RE: CC Case #B5-21/P&Z Case #201-2020, the “Cottages of Northridge.”

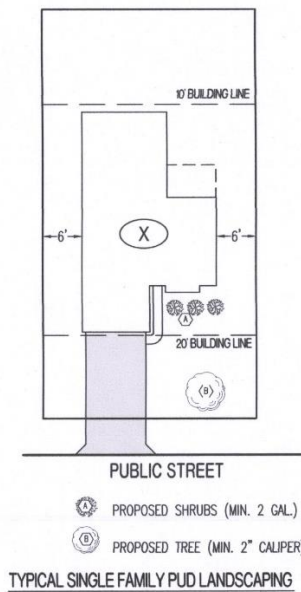
The widths of the existing R-1 lots in this neighborhood generally range between ~65’-0” and ~90’-0”. The proposed width for the cottage lots is generally shown at ~40’-0” and the PUD plan includes the following “typical landscaping plan.”

One of my concerns is that the proposed PUD plan allows 2-car garages in addition to 1-car garages – however the PUD plan does not include a landscaping plan for a home with a 2-car garage. If the garage and driveway width are doubled in the above diagram on a lot 40’-0” wide, it leaves approximately ~5’-0” for a front entrance to the house along the side of the garage and places all of the first-floor living spaces to the rear of the property behind the garage.

Another concern is that while the “landscape diagram” above identifies one possible footprint, there doesn’t appear to be anything in the PUD that prohibits the footprint of the home from extending to the setbacks. Based on an average lot size of ~40’-0” X ~95’-0”, this could result in a ~1,820 SF footprint – including ~240 SF for a 1-car garage or ~440 SF for a 2-car garage. At this size, the footprint of the home is more analogous to a standard single-family home than a “cottage” – on a lot of approximately half the size.
